Impact assessment methodology for connected and automated vehicles [version 1; peer review: 2 approved with reservations]

Open Peer Review

Reviewer Report 15 November 2021

Figure 1. Example of impact diagram set up with three technology areas as impact generators and six possible impact areas and their interrelations.

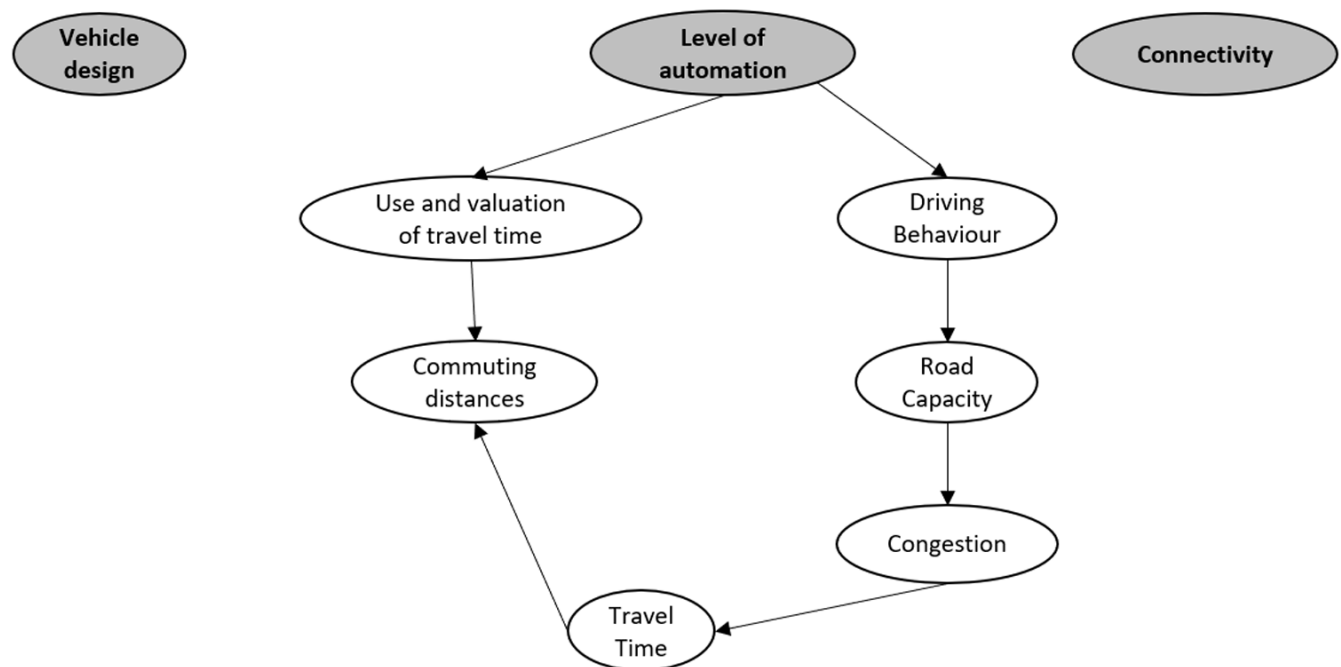
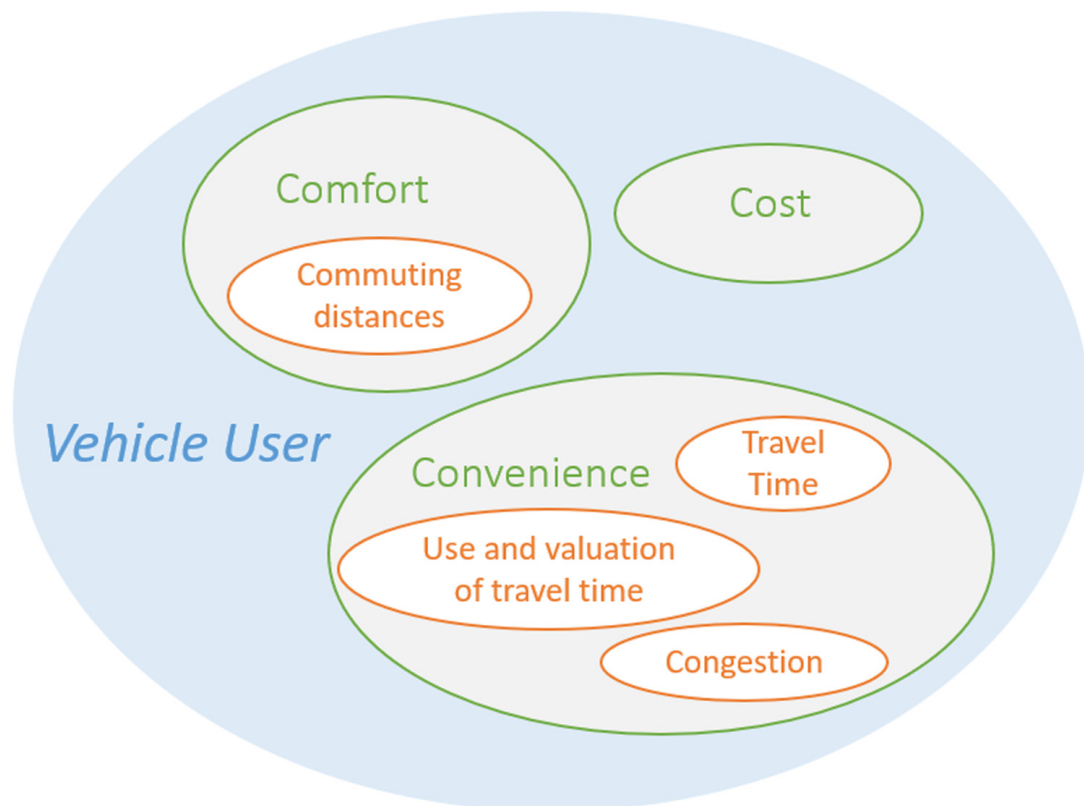
It would have been good to have some more clarity about the terms used and the differences between a "*structured*" approach, a "*holistic*" approach, a "*structured holistic approach*", between causal loop diagrams and feedback loops.

Sometimes the text is rather vague, for example, directly under the heading "Impact assessment method" it says "*The focus is put on the system as a whole from the start, including feedback and interrelations between different impact areas*". It is not clear to me what "*the system as a whole*" is, is it traffic, mobility, society....? Also, it is not clear whether the focus is on vehicles themselves or on the wider mobility system. In table 1 both are being described.

Causal loop diagrams contain both feedforward and feedback loops. Where the former is the impact that happens first after the initial change in circumstances (e.g., introduction of CAV) and the latter loop is a consequence of this impact that feeds back to an earlier impact. For example, Introduction of CAVs could reduce travel time (feedforward loop) as they might make more efficient use of the road available due to shorter time headways. However, when travel time is lower, more people might use the car which will increase traffic flow and reduce traffic time again (feedback loop). To explain this more clearly in the article the following changes have been made:

"The focus is put on the system as a whole from the start, thus including both feedforward and feedback casual relations between different impact areas. Examples of such causal relations are shown in Figure 1. Here the feedforward, or direct, relation is the potential impact of CAV regarding the reduction travel time due to the adoption of shorter time headways. The feedback relation is then the relation between increased traffic flow due to this shorter travel time that in turn increases the travel time."

Figure 1. Example of causal relations between impacts, containing both feedforward (green) and feedback relations (orange).

Figure 5. Primary impacts related to road safety.

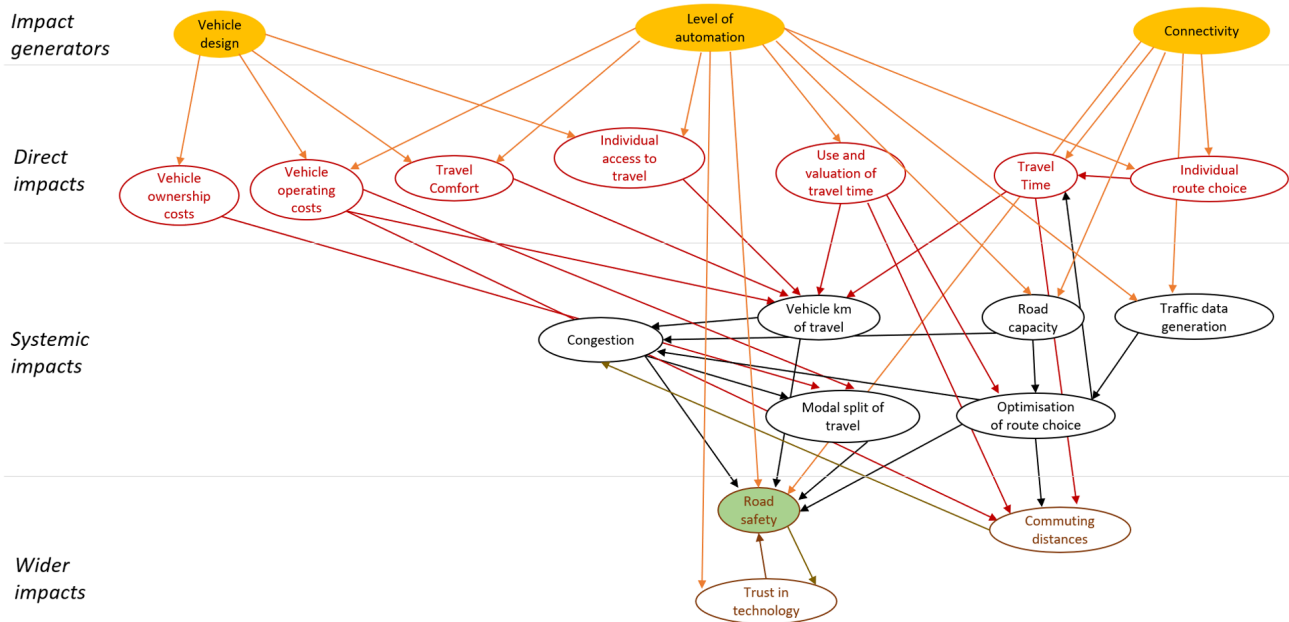
- On page 7, in your description of the example in Figure 5, you say that “Figure 5 shows that AVs affect road safety...” and then you give examples that “they will have lower risk of being involved in an accident” but this in fact cannot be seen from Figure 5. Should you set the example with items visible in the graphics?

"On page 7, in your description of the example in Figure 5, you say that "Figure 5 shows that AVs affect road safety..." and then you give examples that "they will have lower risk of being involved in an accident" but this in fact cannot be seen from Figure 5. Should you set the example with items visible in the graphics?"

"Figure 5 shows that automated vehicles affect road safety directly (primary impact) via many routes, for example, they will probably have a lower risk of being involved in a crash than human driven vehicles, with the risk decreasing with increasing the level of automation. This impact is indicated in Figure 5 with the arrow between "level of automation" and "road safety". Especially if vehicles are able to communicate with each other, i.e. if they are connected (CAVs), the risk of a crash will probably be reduced. This additional improvement on road safety is indicated with the arrow between "connectivity" and "road safety".

Figure 6. Secondary impacts related to road safety.

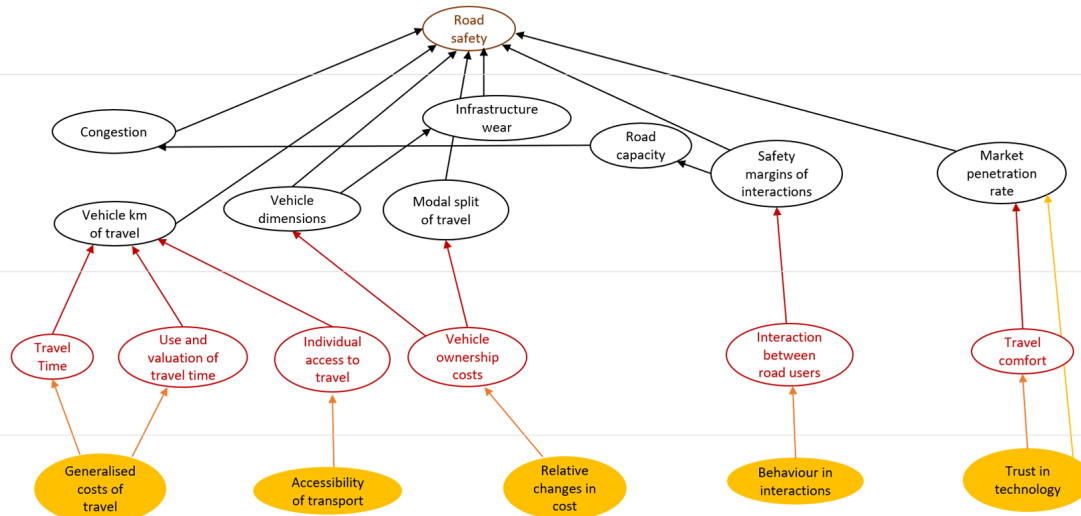
- On pages 8-9 you tell of “rebound effects”. Without knowing the direction of the impacts, it is hard to know whether they boost the impact or reduce it. Thus, I would reconsider calling it “rebound effect”, or at least I would add the word “potential” there to hint that these may potentially reduce the impact and therefore they are worth checking. It is hard to make a complete list of all potential rebounding effects. Potentially rebounding factors that are now not listed in Figure 4 and which are relevant include at least adaptation of driving style when AV user drives manually outside ODD (for at least users of SAE3 cars) and adaptation of the driving behavior of non-users in traffic with large penetration of AVs. If the driving outside ODD and of non-users are affected, they will have an impact, too.

"On pages 8-9 you tell of "rebound effects". Without knowing the direction of the impacts, it is hard to know whether they boost the impact or reduce it. Thus, I would reconsider calling it "rebound effect", or at least I would add the word "potential" there to hint that these may potentially reduce the impact and therefore they are worth checking. It is hard to make a complete list of all potential rebounding effects. Potentially rebounding factors that are now not listed in Figure 4 and which are relevant include at least adaptation of driving style when AV user drives manually outside ODD (for at least users of SAE3 cars) and adaptation of the driving behavior of non-users in traffic with large penetration of AVs. If the driving outside ODD and of non-users are affected, they will have an impact, too."

We agree that the word "rebound" does not cover all feedback effects shown in Figure 6. We adjusted the text as follows.

In addition, some potential feedback effects can be expected as shown in Figure 6. Such feedback effects can either amplify or reduce the original impact. The driving behaviour aspects you mention are currently captured under the impact generators "behaviour in interactions" and "level of automation". We especially endorse the mentioned importance of including adaptive behaviour of non-AV-users to driving among AV, as this is an often overlooked effect. Within the LEVITATE project we have therefore conducted a driving simulation study investigating such effects and will soon publish a paper about the results.
